Informative Spec Values Recommendations

Richard Mellitz, Intel

6/1/2005

69.3.3 Insertion loss

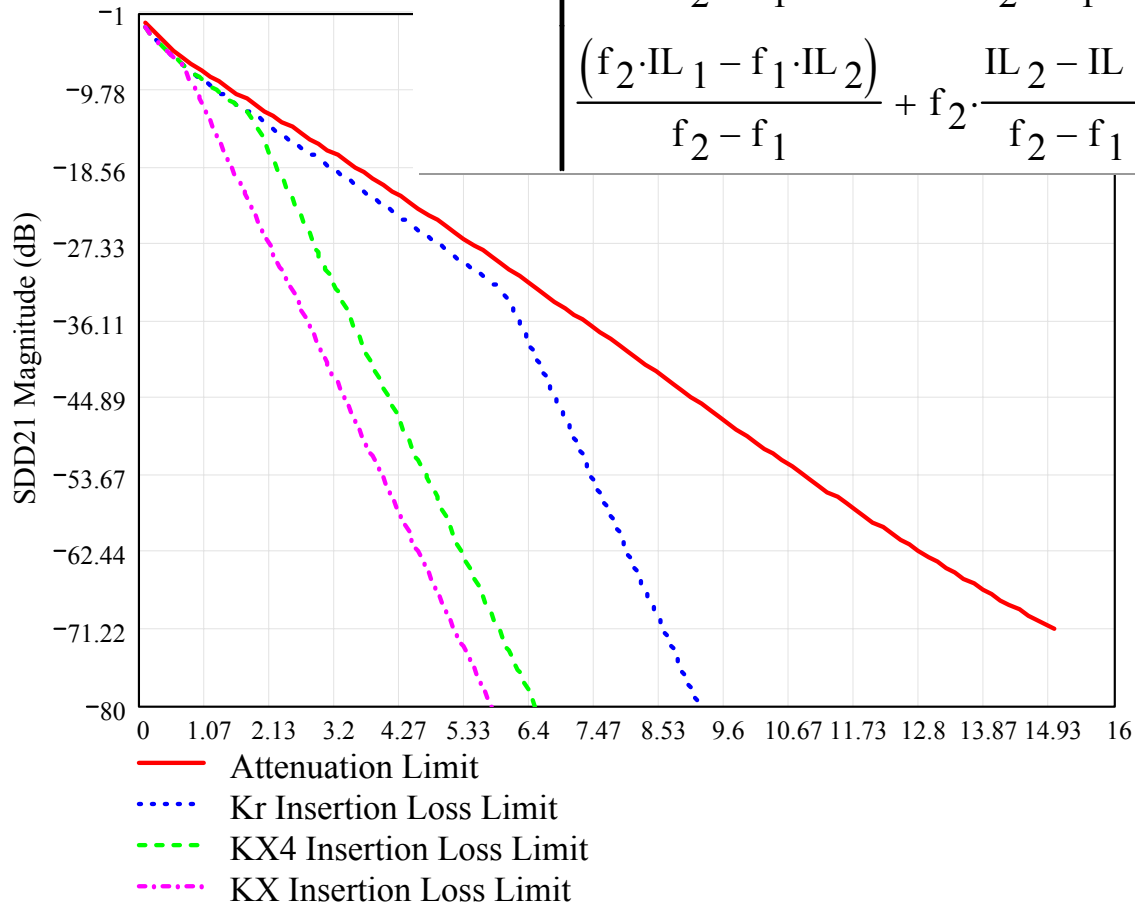
Suggested Change

$$IL(f) = \begin{cases} \frac{(f_2 \cdot IL_1 - f_1 \cdot IL_2)}{f_2 - f_1} + f \cdot \frac{IL_2 - IL_1}{f_2 - f_1} & \text{if } f_1 \leq f \leq f_2 \\ \frac{(f_2 \cdot IL_1 - f_1 \cdot IL_2)}{f_2 - f_1} + f_2 \cdot \frac{IL_2 - IL_1}{f_2 - f_1} - m_{HF} \cdot (f - f_2) & \text{if } f_2 \leq f \leq f_{\max} \end{cases}$$

69.3.3.2 Insertion loss deviation

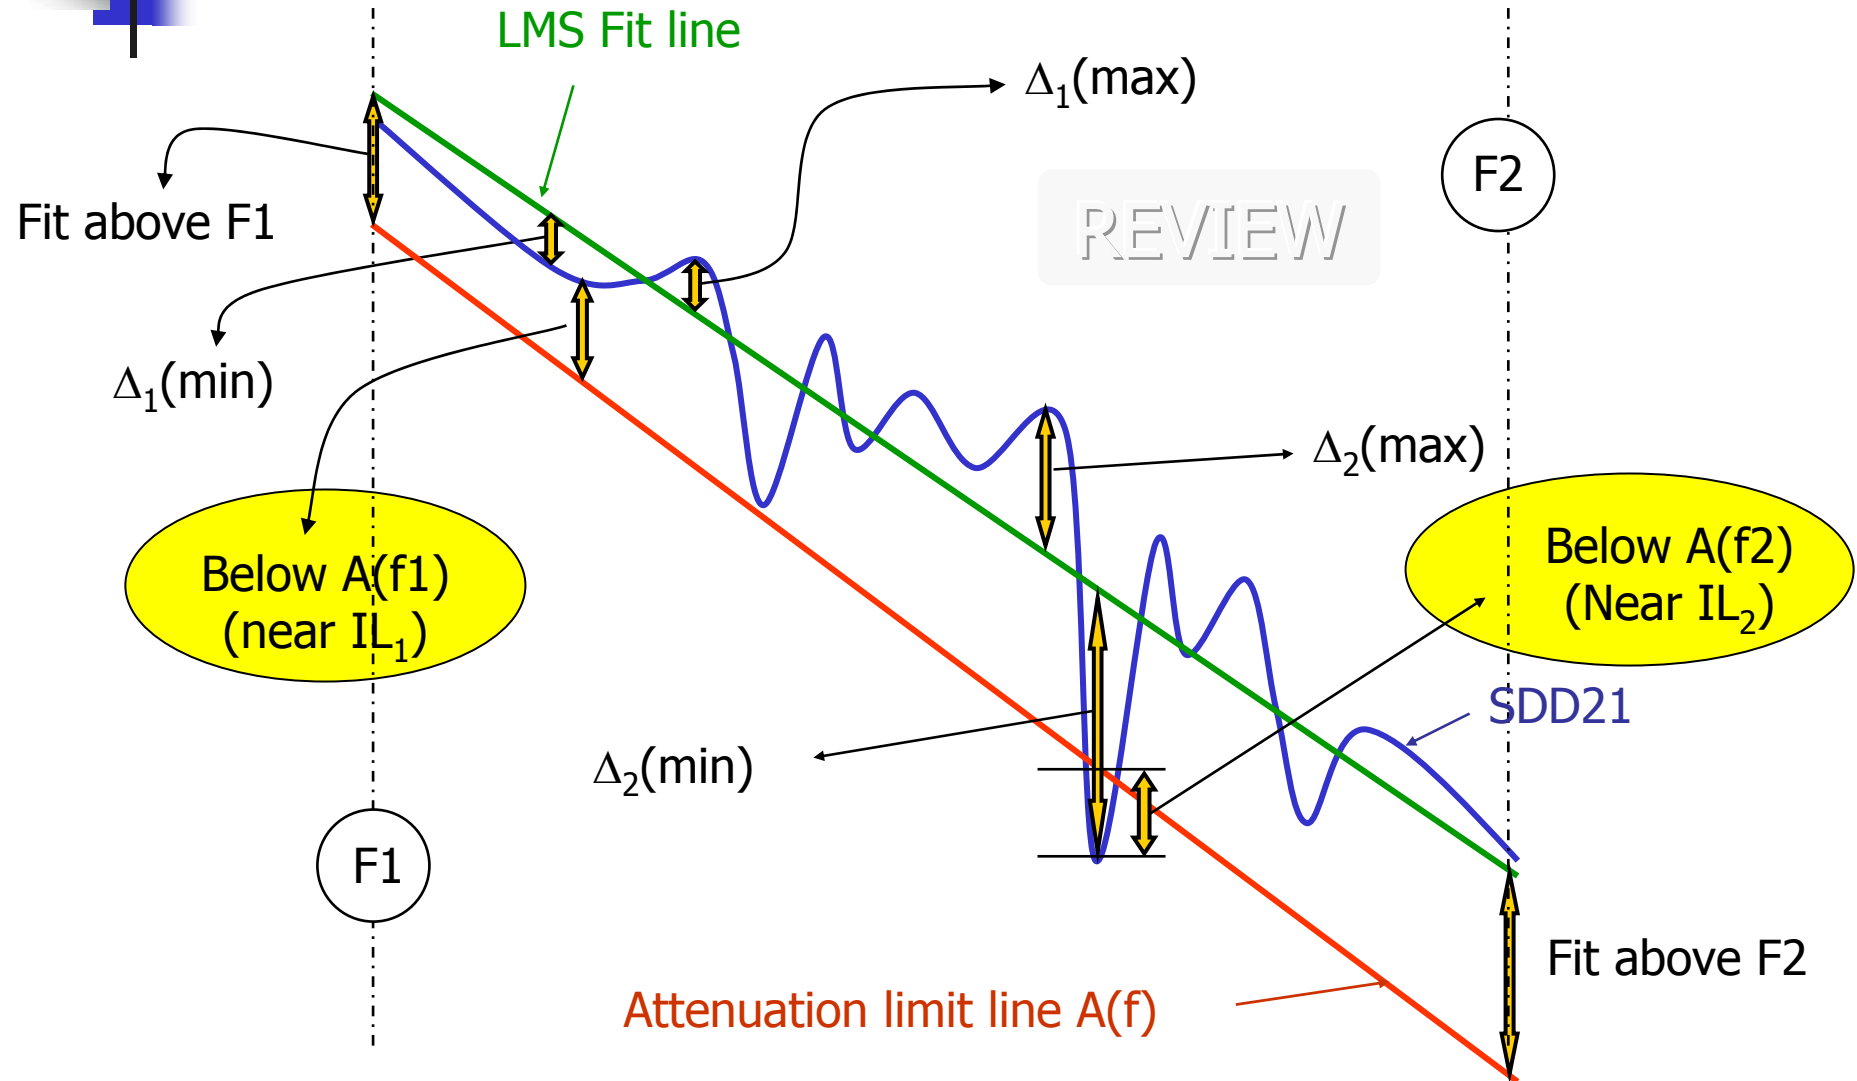
- Add equation: $ILD(f) = SDD21(f) - LMS_fit(f)$

Ripple parameter concept

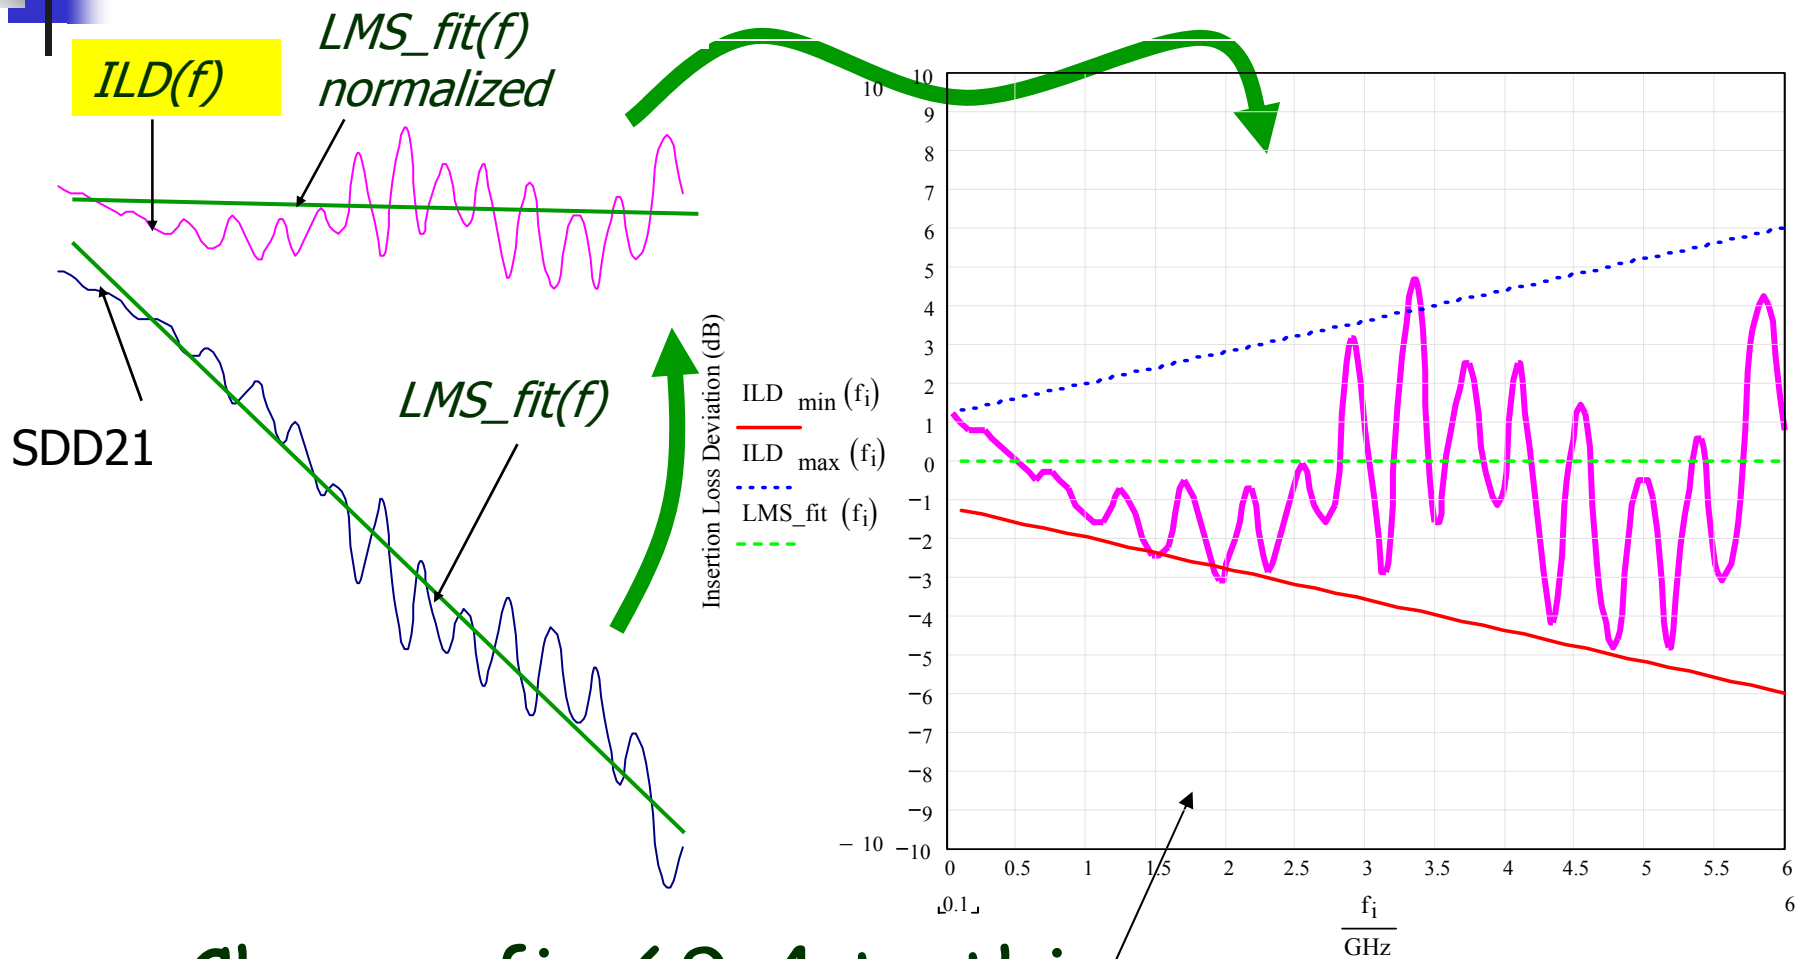
■ Change fig 69-4 to this

dB below fit line vs. 1dB@1GHz, 3dB@6GHz limits

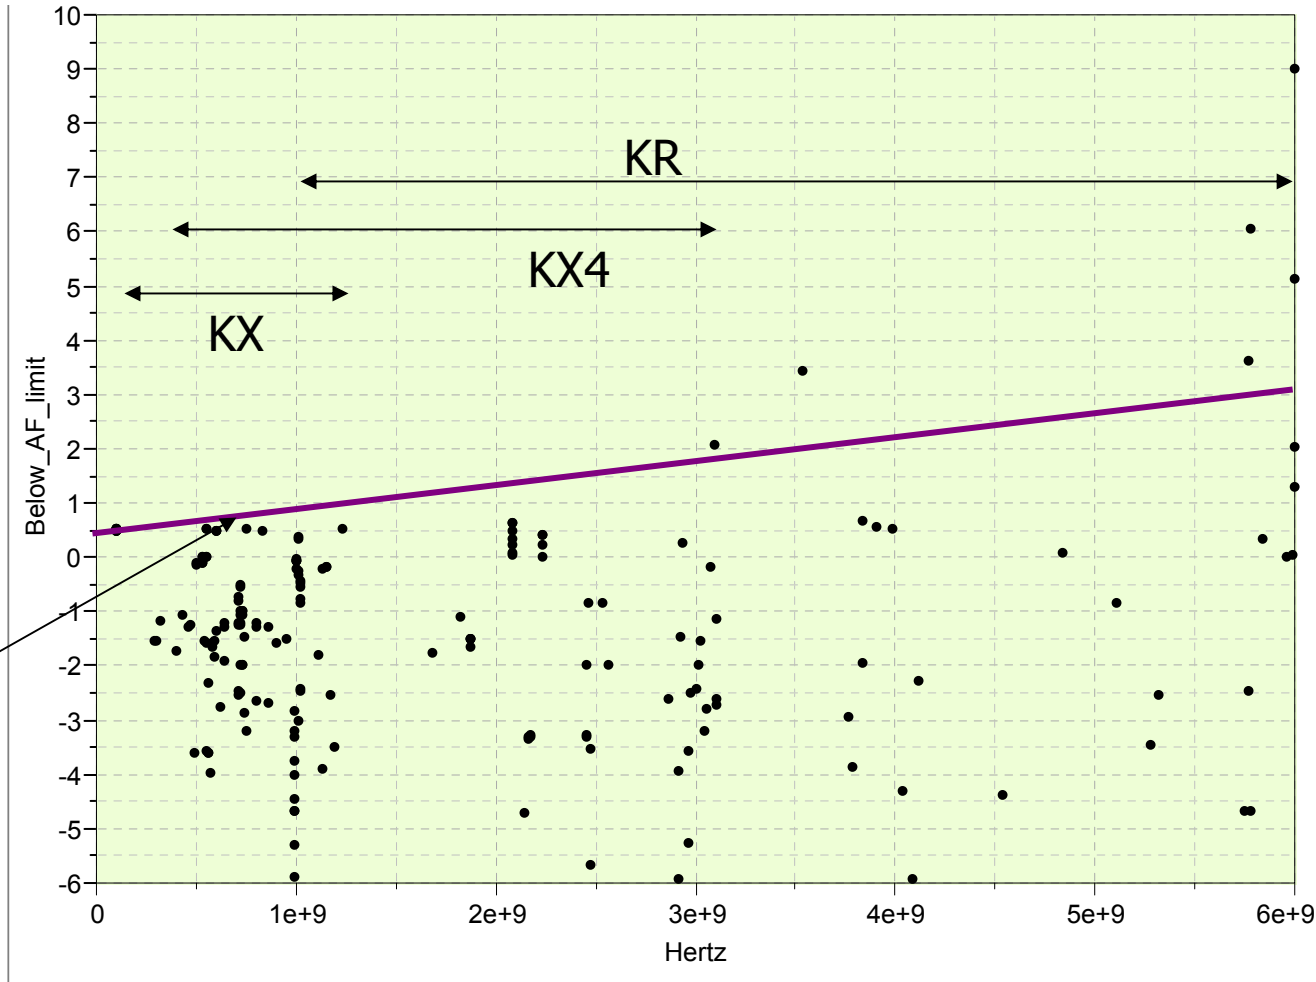
If we choose a line at 1 an 3 dB then the following are above the line

Case3 FM 13SI 20 T D6 L10.s4p
 peters_01_0305_T12.s4p
 peters_01_0305_T20.s4p
 peters_01_0904_T12_thru.s4p
 peters_01_0904_T20_thru.s4p

$$\text{Below_AF_limit} = f \cdot 4 \cdot 10^{-10} \text{sec} + .6$$

Δ Max peaks

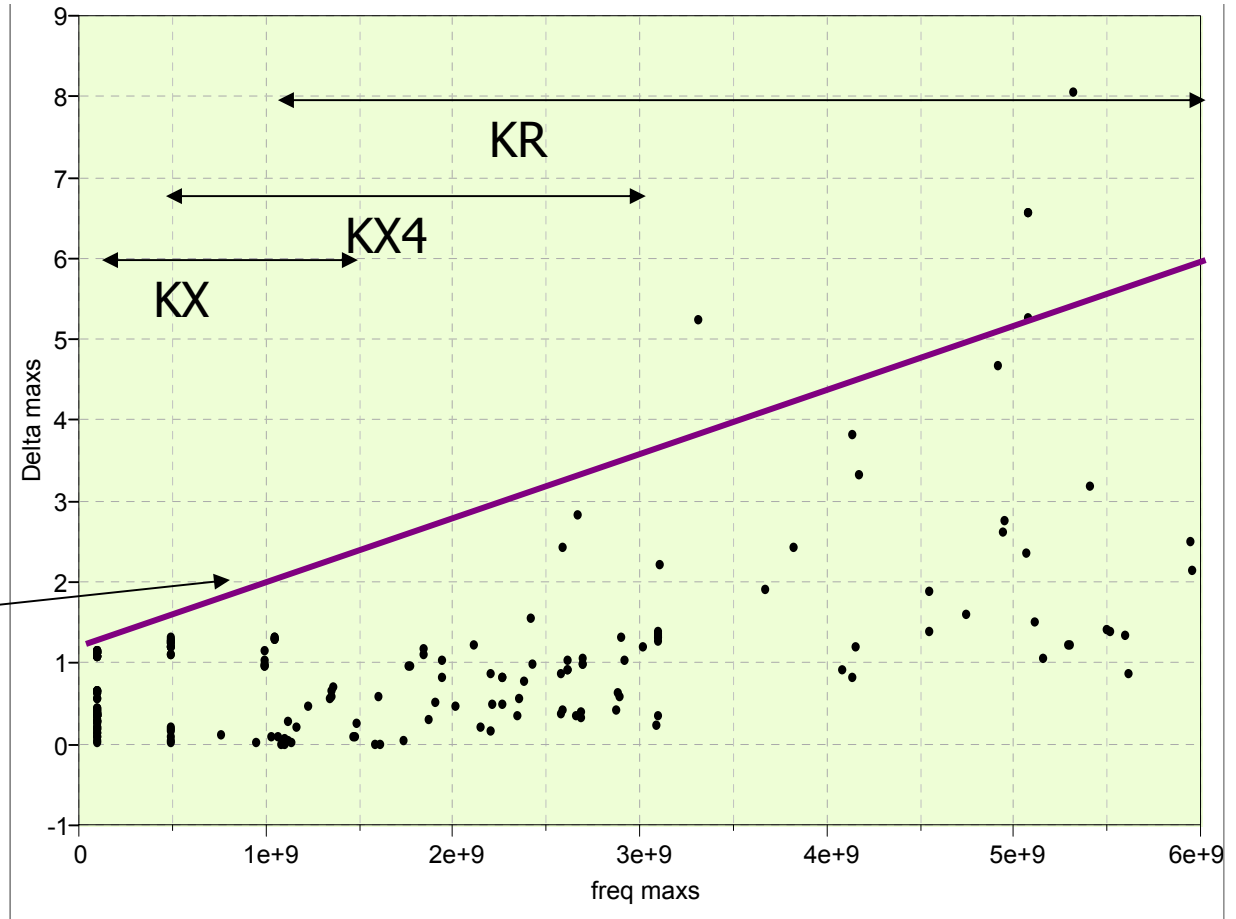
The following are above the line

peters_01_0305_T1.s4p
peters_01_0904_T1_thru.s4p

$$\Delta_{\text{max_limit}} = f \cdot 8 \cdot 10^{-10} \text{ sec} + 1.2$$

Δ Min peaks

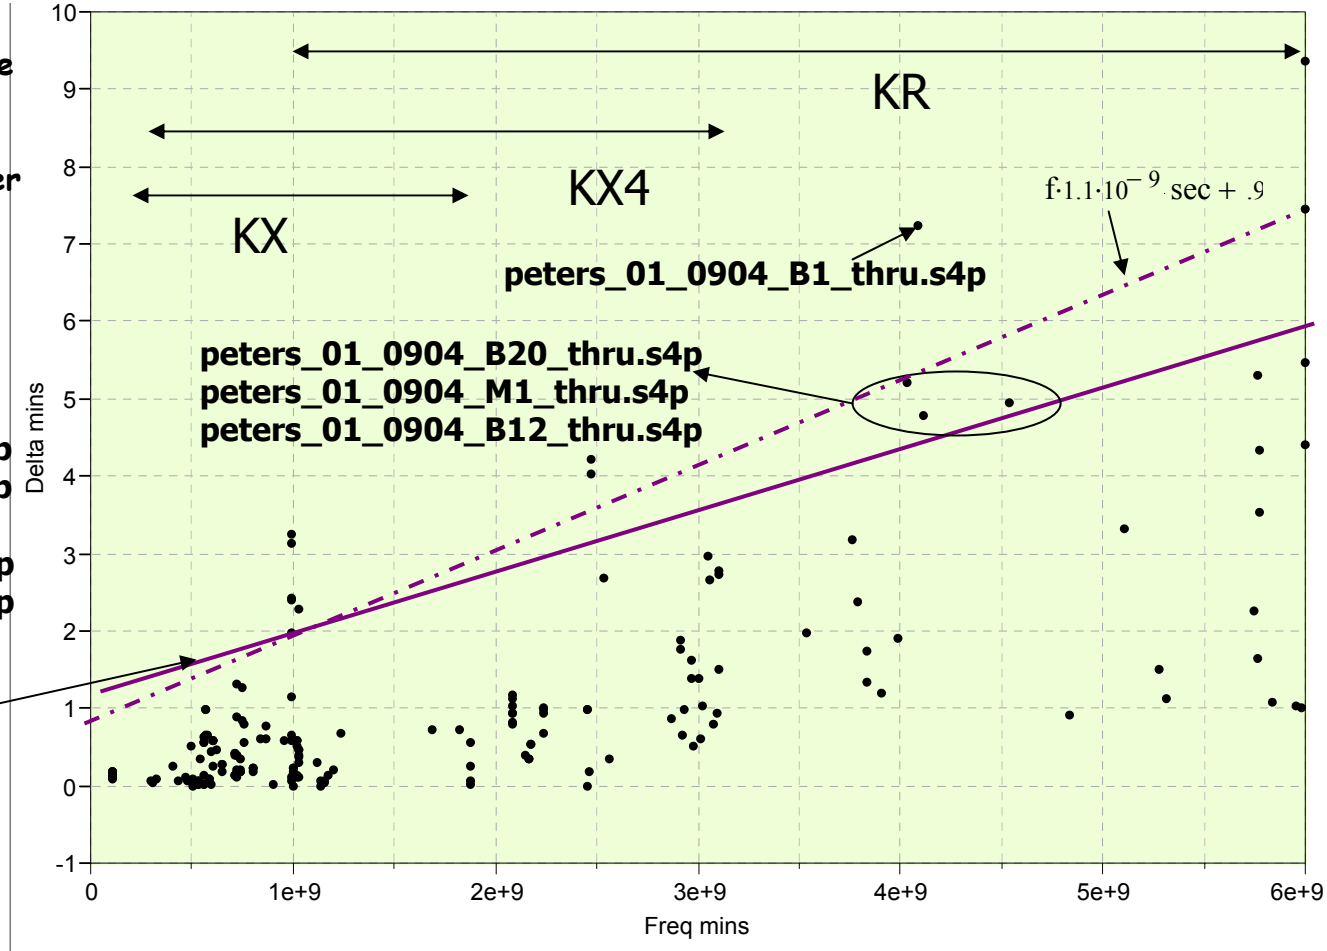
The following are above the line
note: min's are reported as a
positive number here but
correspond to a negative number
in the spec.

peters_01_0305_T1.s4p
peters_01_0305_T12.s4p
peters_01_0305_T20.s4p
peters_01_0904_T1_thru.s4p
peters_01_0904_T12_thru.s4p
peters_01_0904_T20_thru.s4p
peters_01_0904_B1_thru.s4p
peters_01_0904_B12_thru.s4p
peters_01_0904_B20_thru.s4p
peters_01_0904_M1_thru.s4p

$$\Delta_{\text{min limit}} = f \cdot 8 \cdot 10^{-10} \text{ sec} + 1.2$$
